## Firmware 2.06.3 bug list:

## List of bugs/improvement requests

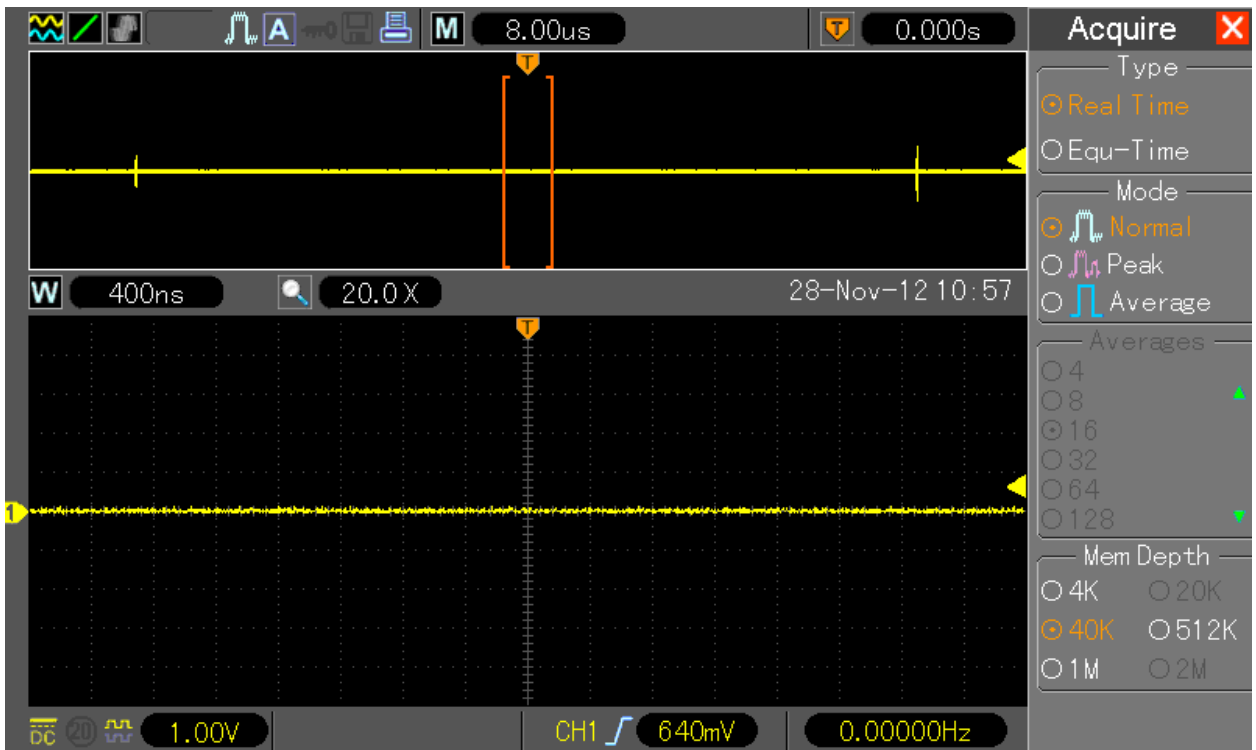
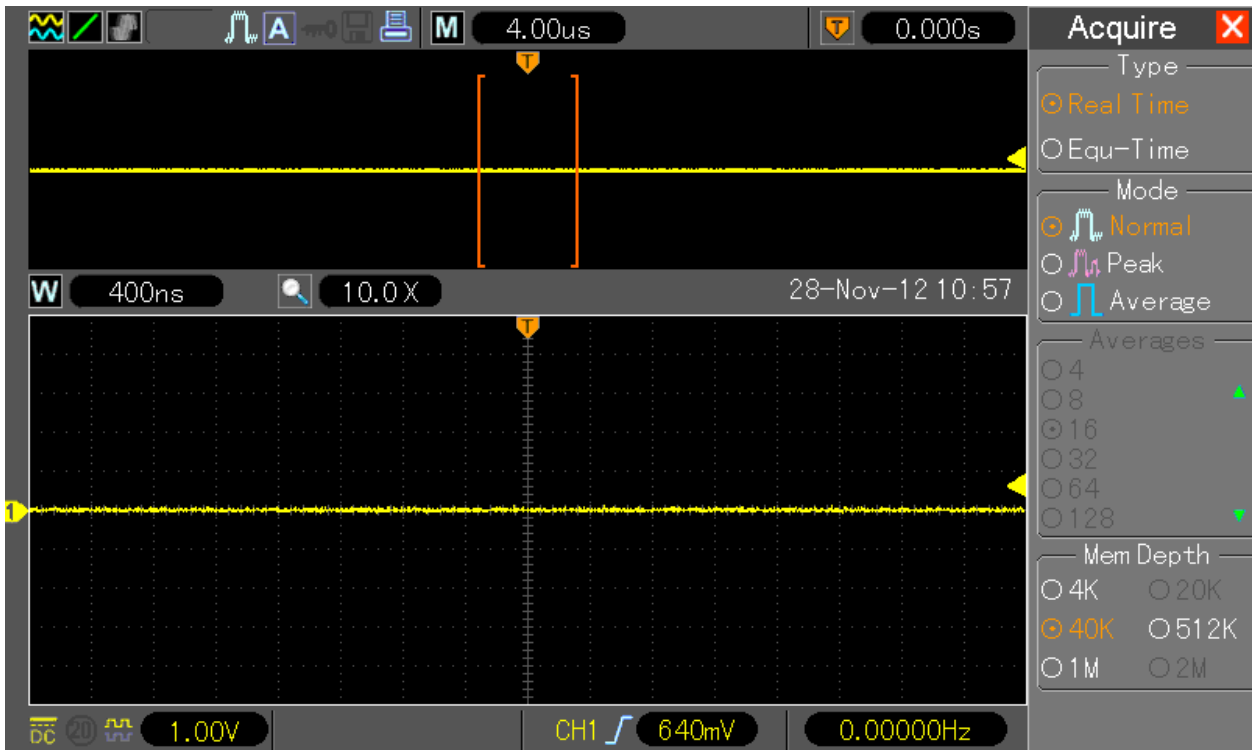
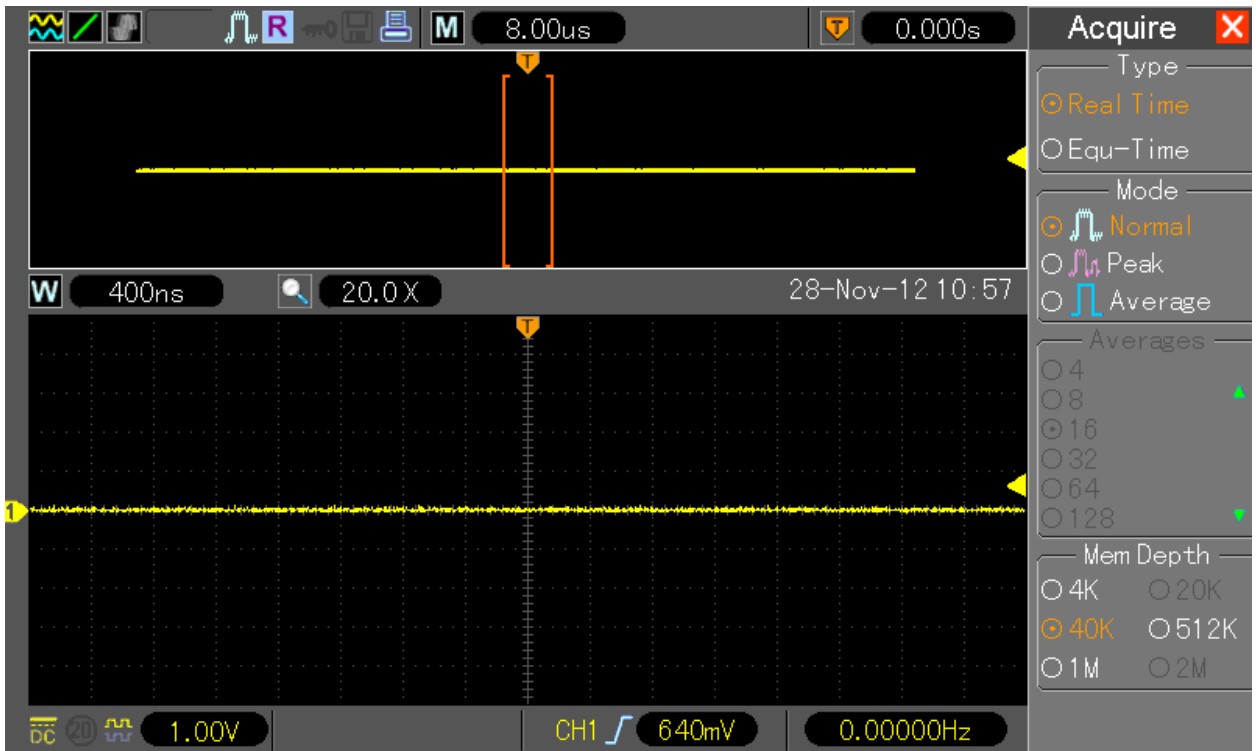
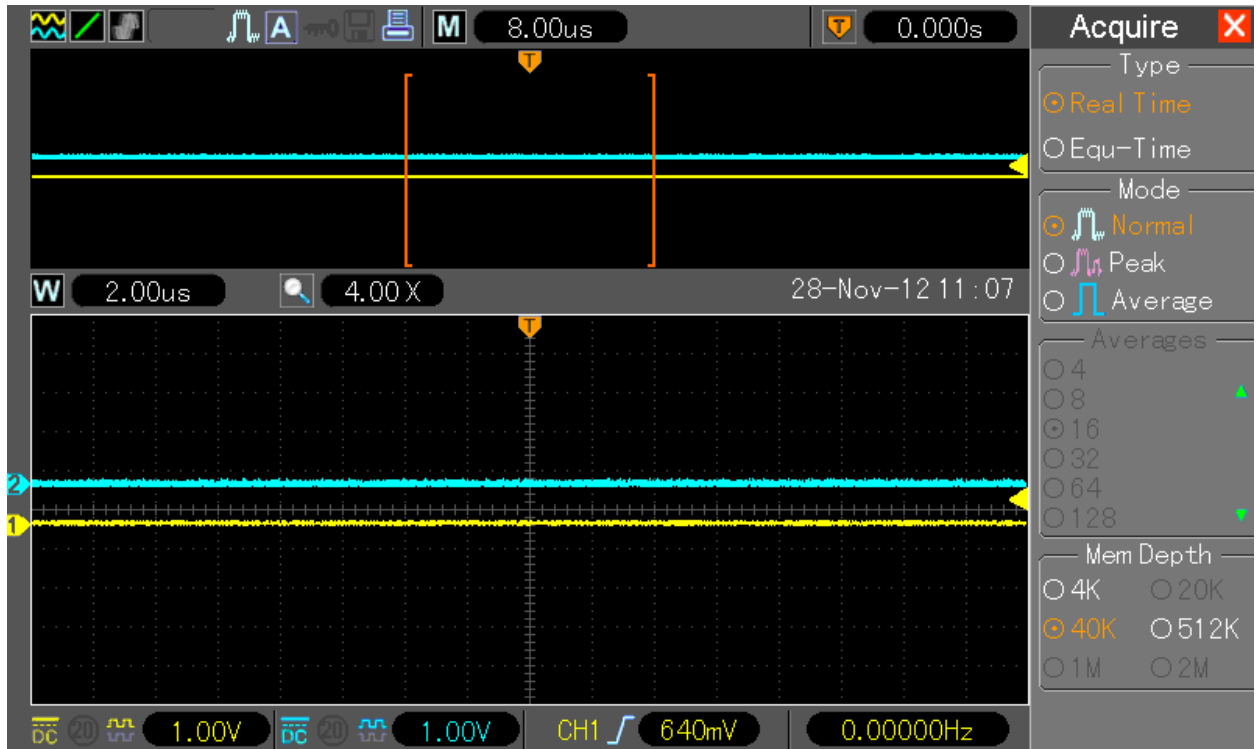
27. While switching from single into dual window mode the main timebase is changing with a wrong factor, e.g. from 200ns/DIV in single into 400ns/DIV in dual window mode. Similar issue in 40k/512k and 1M – in dual window the MTB is twice that high as before in single window mode. Due incorrect timebase the display buffer is showing artifacts on both right and left side of the waveform (end of buffer). Example: CH1 enabled, 40k memory, single window and windows timebase smaller than main timebase, here 400ns/DIV (Main TB is 4us/DIV for 40k)

Now when switching to dual window the Main TB is changing to wrong value (here from 4us/DIV to 8us/DIV – actually it will be always doubled in length) and artifacts from “end of buffer” right and left in top window are shown:

When the Acquisition would be stopped and restarted or Timebase changed one position forth

and back (while Main window is focused) the Main TB and displayed data will be fixed to proper length; no artifacts shown anymore:

With 2 channels enabled this bug **DOES NOT EXIST**, this is because the doubled Main TB value is exactly what it should be for dual channel view:

26. ~~Just ignore it for now; it is interim fw version — for testing only.~~ This is no in production firmware as well, very annoying bug.
27. Switch once focus from minor (bottom window) to major (top window) window by pushing timebase knob down, turn then timebase one position fort and back to get rid of waveform artifacts on left and right side of the waveform.

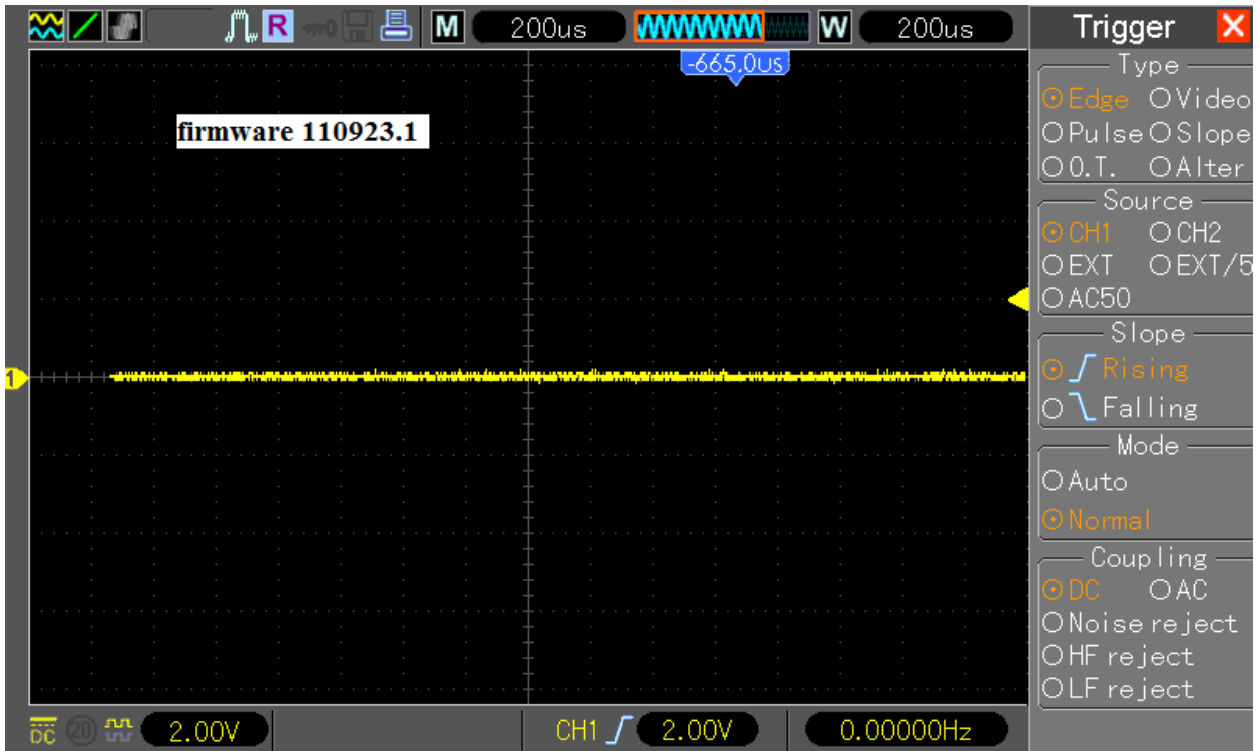
28. Someone told me that there was “problem in csv exported data, no timestamp inside. This seems to be fixed in 2.06.3\_121027.0”. Honestly, I see timestamp in scientific format but no idea if this is really fixed; for me it’s a bit strange when multiple data points are on same stamp, e.g. (steps are here in ns valued but then cut in format):

If the smallest step is e.g. 40ns then timestamp for every point should be always in ns and not increasing:

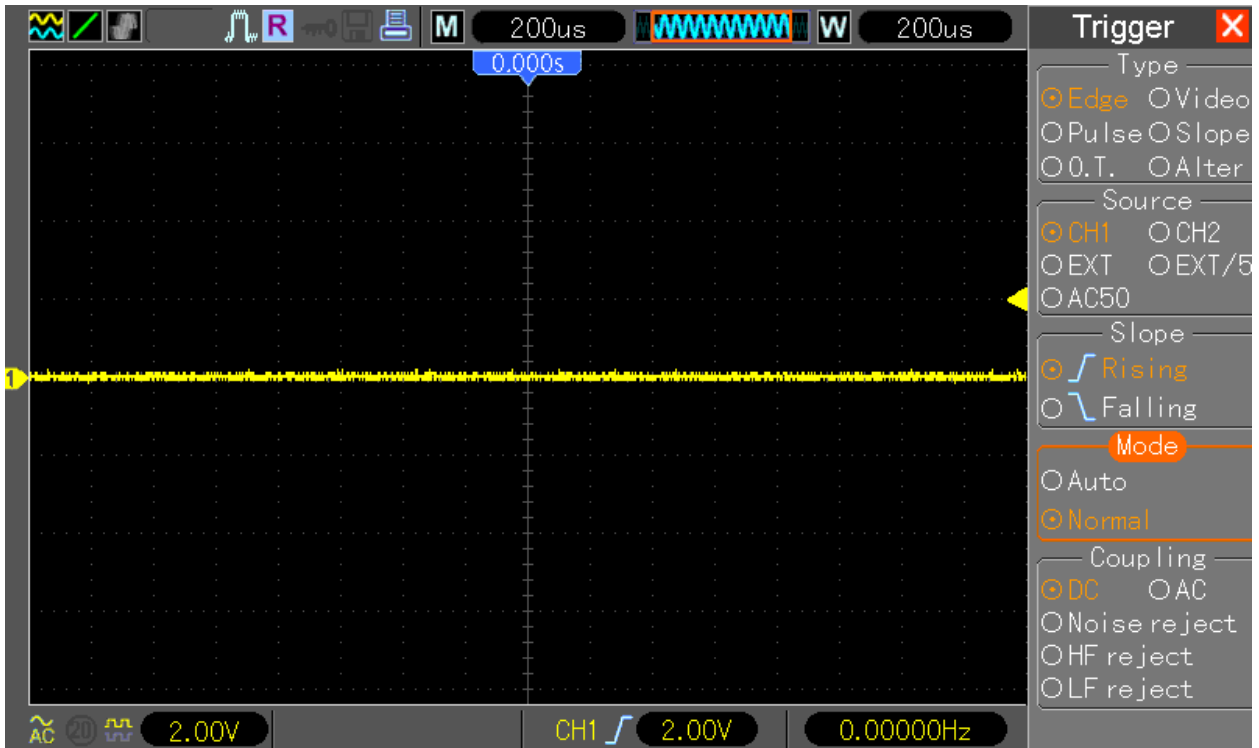
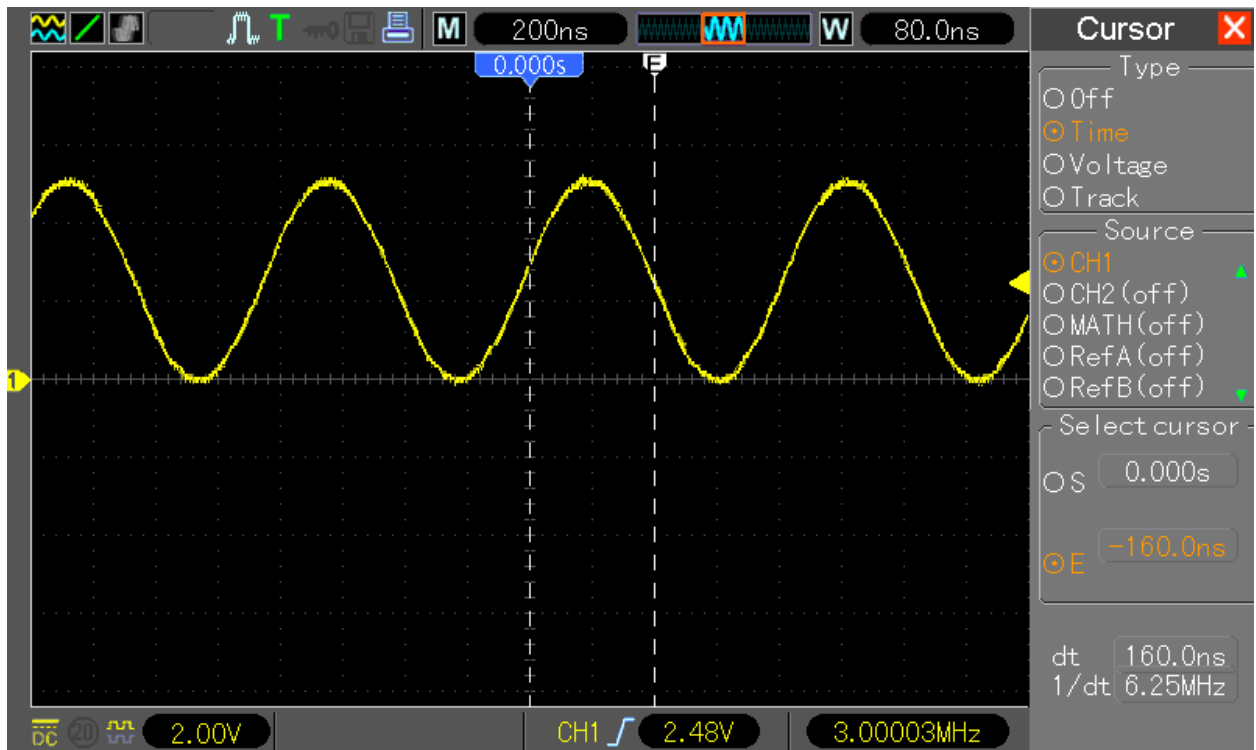
29. Horizontal Position knob not moving display data. Set Trigger to “Normal” – when DSO not triggered the waveform/horizontal screen position cannot be changed. Once triggered it changing rapidly. Another example – set trigger to Single Seq and Auto , while trigger in “R” (ready) mode waveform/horizontal screen position cannot be moved. Again, once triggered it change rapidly. **In firmware 110923.1 this was working! :**

but since few firmware version not anymore working (same condition, Horizontal position knob already turned few times but no move on screen):

**Generally, bug 29 and 30 have something to do (in my opinion) with the fact that screen data is dependent on trigger. You can easily see the difference e.g. in cursor, while moving them with no trigger (e.g. normal mode, trigger level above signal level) the cursor is working just fine.**

**Maybe it would be good idea to remove the trigger event link from screen refresh (why is this linked together anyway? It cannot be necessary for the firmware because older versions never had this bug).**

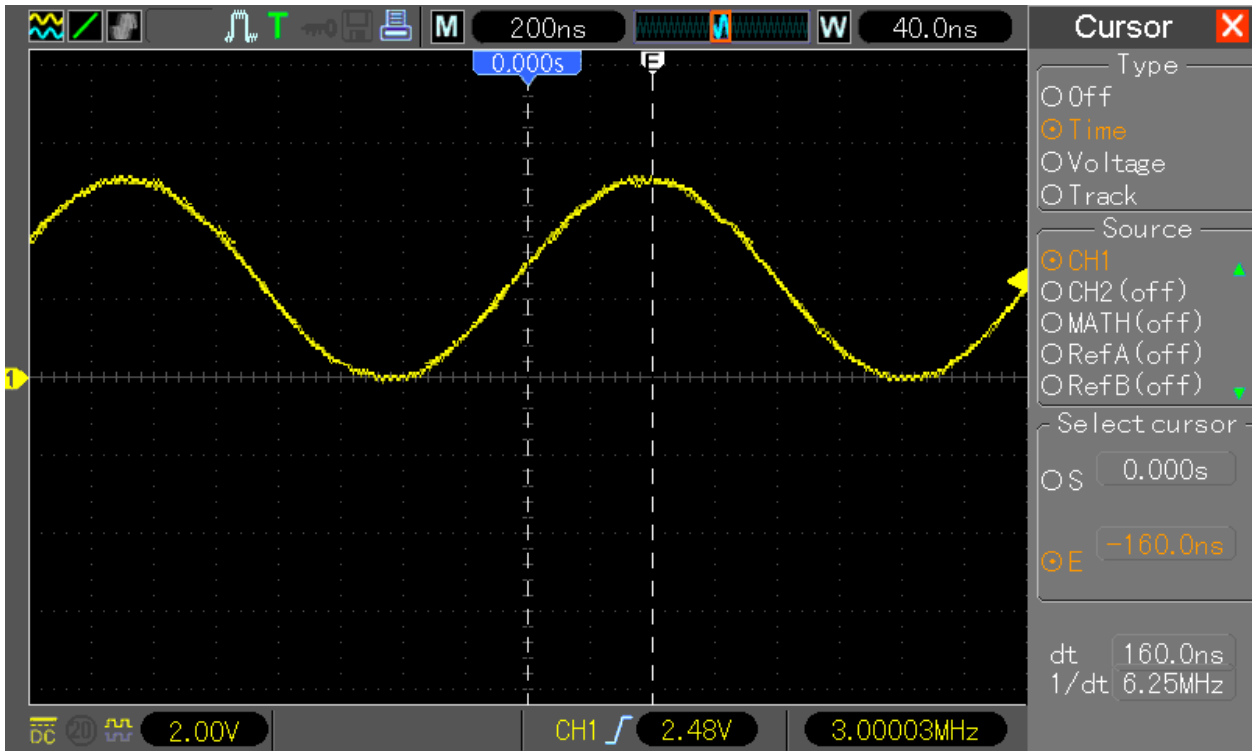
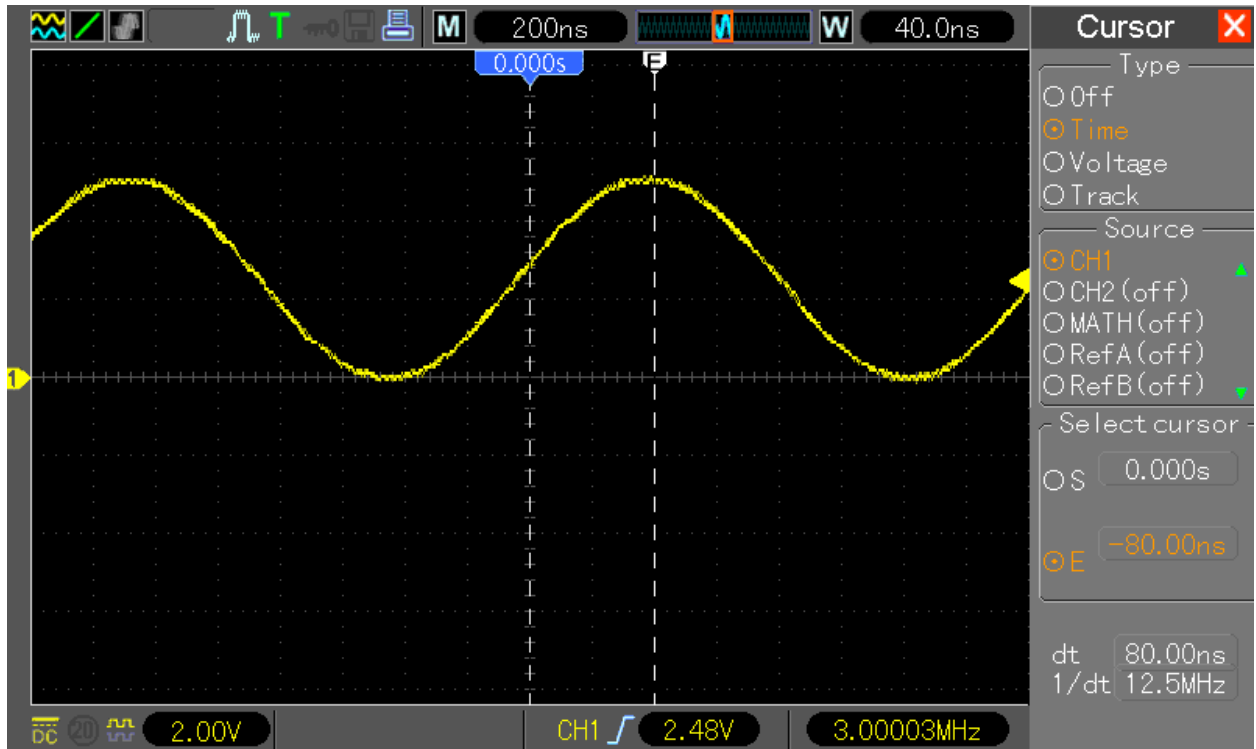
31. In RUN and STOP mode, while changing Timebase the Time Cursor values S and E not refreshing automatically. Any changes to Menu (hide/show with F0), other Knobs (like V0) position or any Buttons (e.g. push Measure button and again Cursor button) is refreshing the S and E values in Menu.

Here example, TB set to 80ns/DIV, cursor S to 0.0ns and E to -160ns:

Then TB changed to 40ns/DIV, but displayed value for E still -160ns:

Now disabling Menu with F0:

and enabling Menu again with F0. The E cursor value is now having proper value (-80ns):

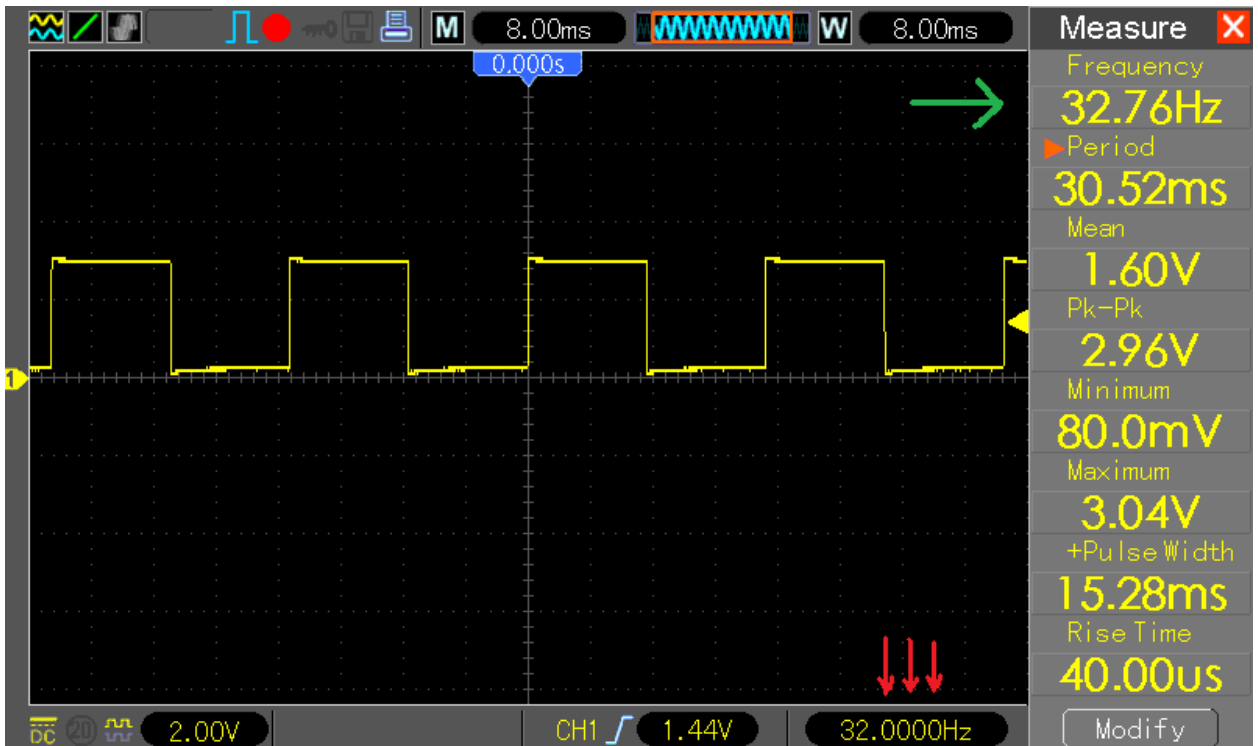
34. CSV Exported data, if MTB from 40s/DIV to 4ms/DIV the amount of samples is wrong as well the displayed MTB value seems to be wrong. Example :
  - 4k depth, 4ms/DIV -> CSV shows #timebase= -294967296(ps) and not 400000000(ps)

**The number -294967296 is nothing else than buffer overflow by 3999999999, -589934592 buffer overflow by 7999999999, etc.**

A quick check of “SaveWaveDataToCSVFile” shows the problem source ->

**sprintf “#timebase=%d(ns)\r\n,”** is using %d but I think %lld was supposed to be there to allow maximum of 40s/DIV to be saved in pico seconds. The “RecallCSVDataToDispBuf” need of course to be changed as well to allow read-back of the CSV data longer than 2000000000 ps.

32. Nothing to say here.
33. Nothing to say here.
34. We could patch it with Hex Editor from %d to %lld to allow CSV export, but import need to be changed in source code (to work properly), so I would say “let’s wait for official fix”.
